Steven Velardo
164 East Middle Patent Road
Bedford, NY 10506

RE: 164 East Middle Patent Road
Bedford, NY 10506
Section 95.02 Block 2 Lot 22

Thank you for the opportunity to present my revised submission based on the comments from the previous Planning Board meeting of November 9, 2020.

Staff Comments Planning department memo dated 11/3/2020

Drawn By: JA
 Project #: 01-20
 Sheet Number:
LW-1
 Scale: 1" = 20'-0" Issue Date: February 22, 2021

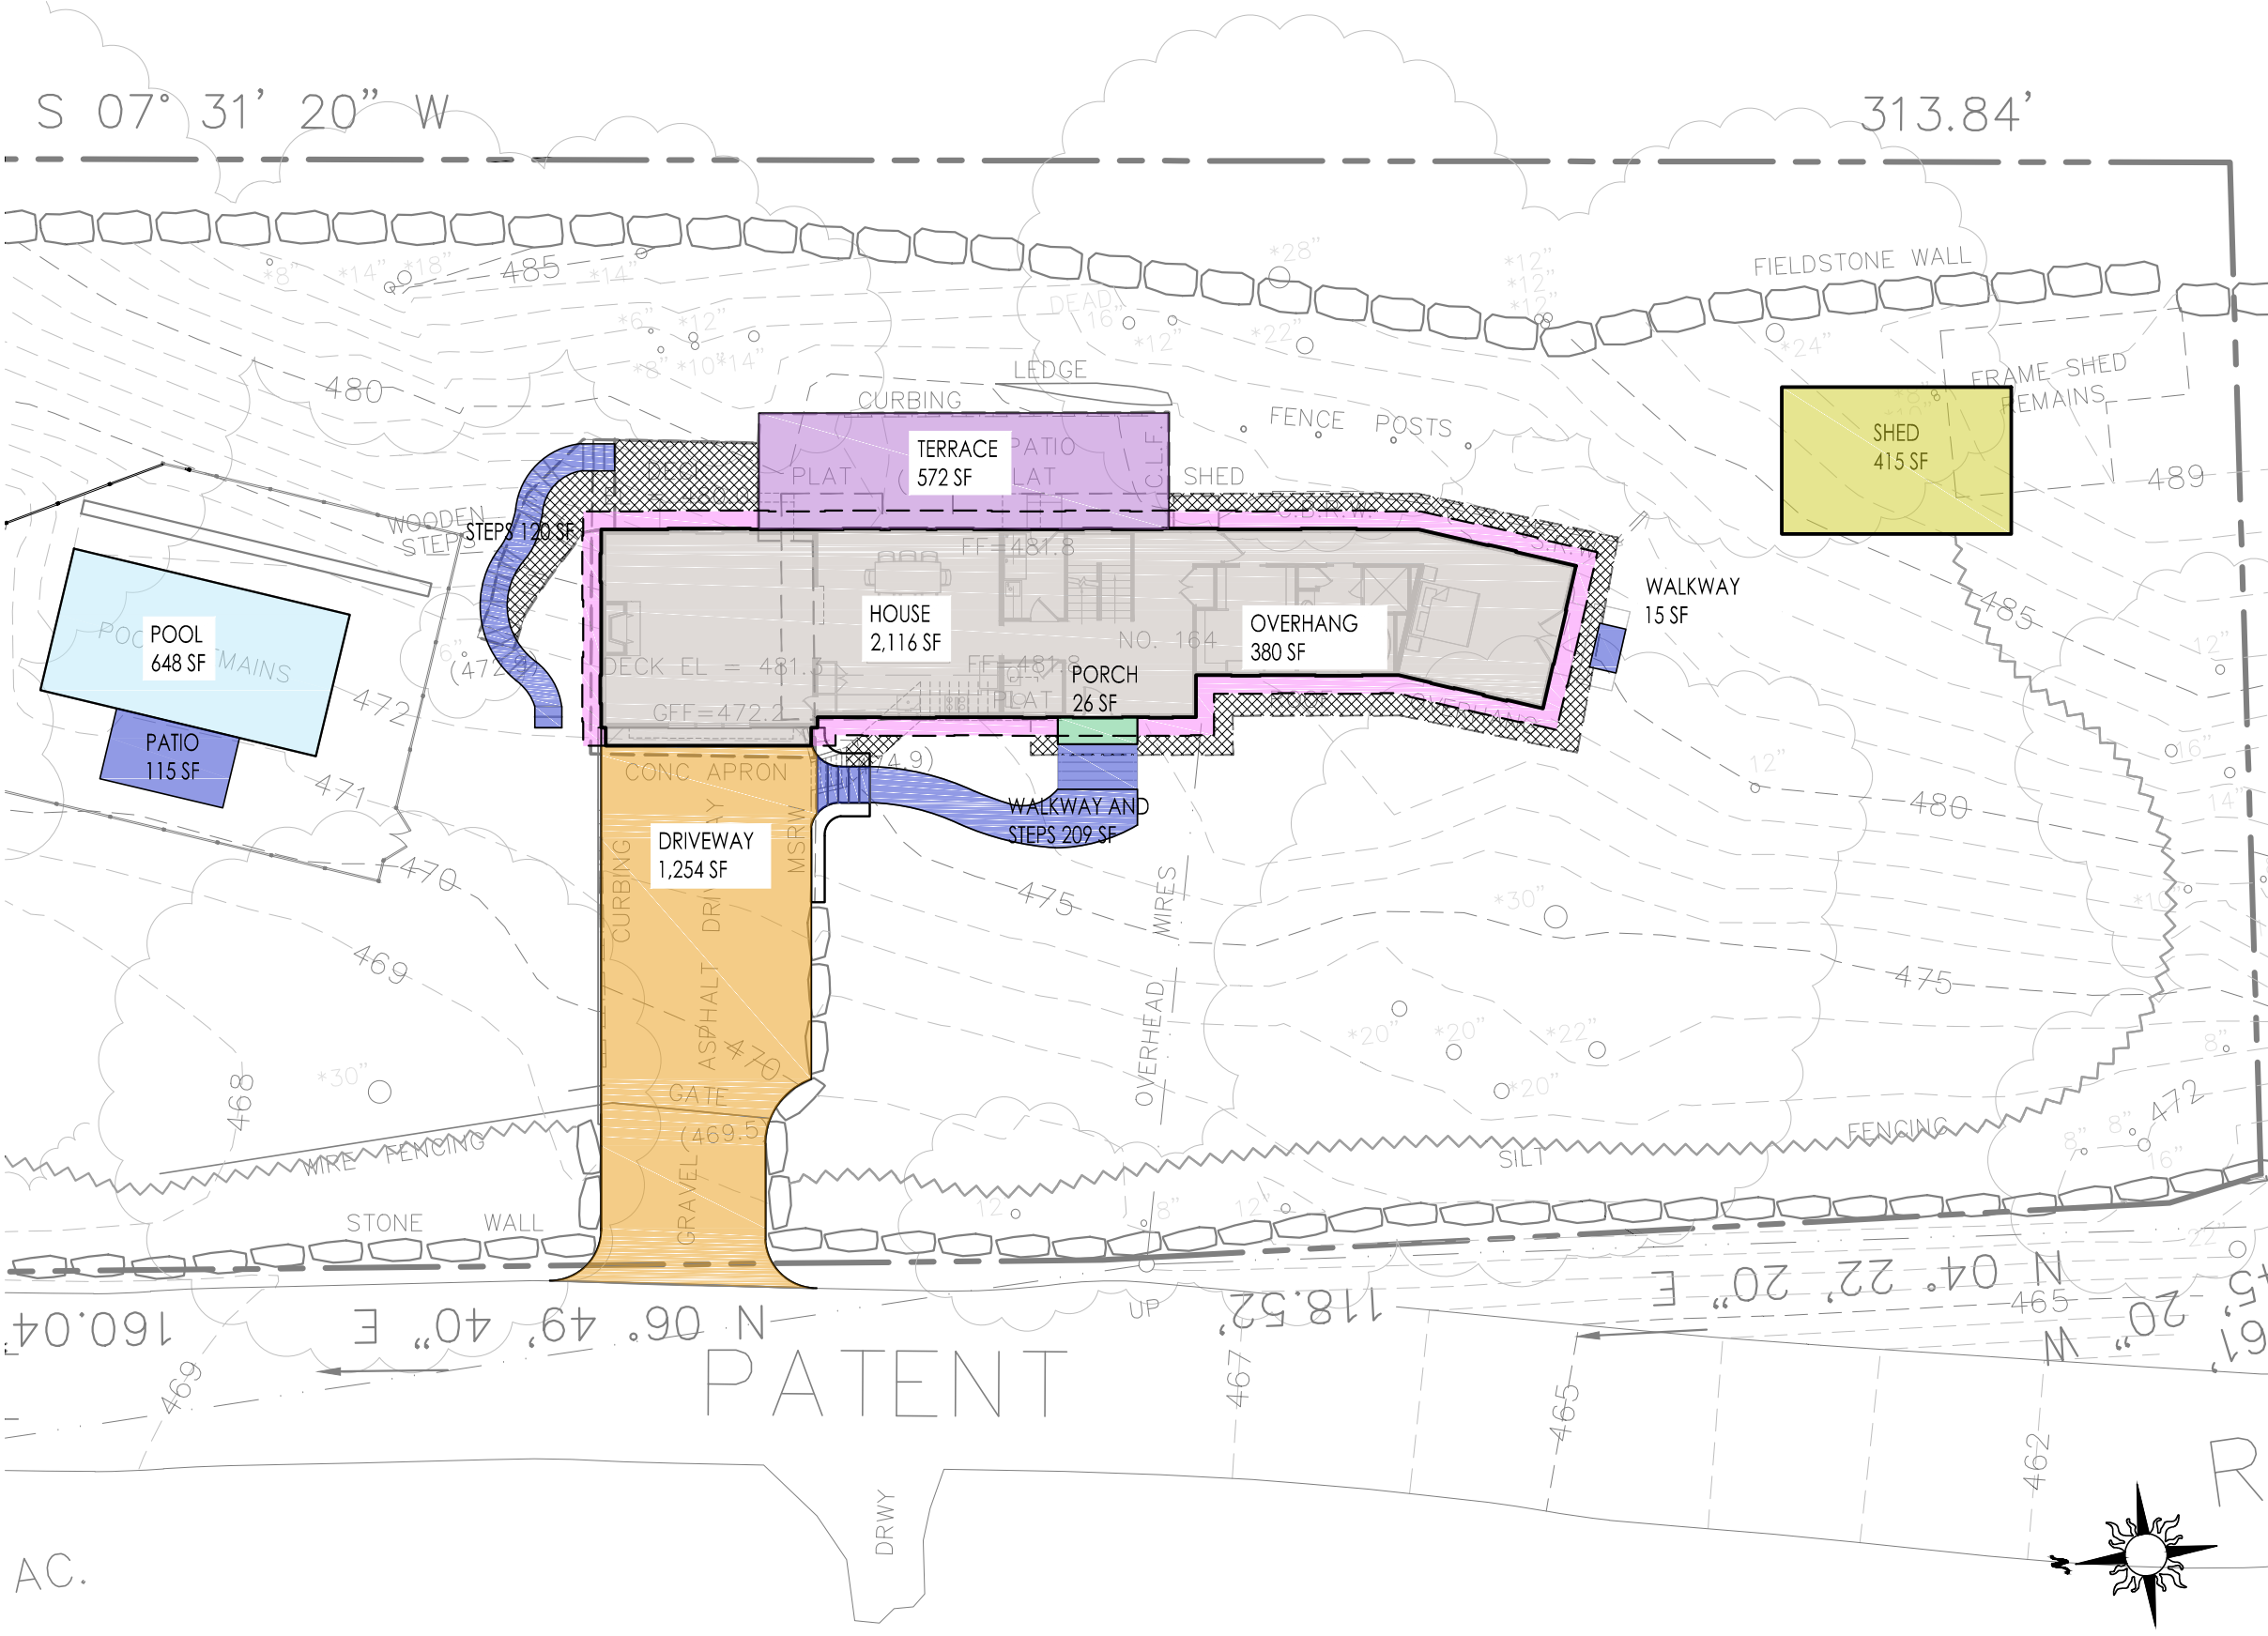
4. The applicant shall prepare a Mitigation Plan, in accordance with Chapter 340-9,

As proposed on Revised Wetlands Mitigation Plan LW-1 Dated 1/25/2021

As proposed on Revised Wetlands Mitigation Plan LW-1 Dated 1/25/2021

As proposed on Revised Wetlands Mitigation Plan LW-1 Dated 1/25/2021

As proposed on Mitigation Plan LW-1 Dated 1/25/2021

As proposed on Mitigation Plan LW-1 Dated 1/25/2021

As proposed on Revised Mitigation Plan LW-1 Dated 2/22/2021 with revisions based on resolution for approval by the Conservation Board.
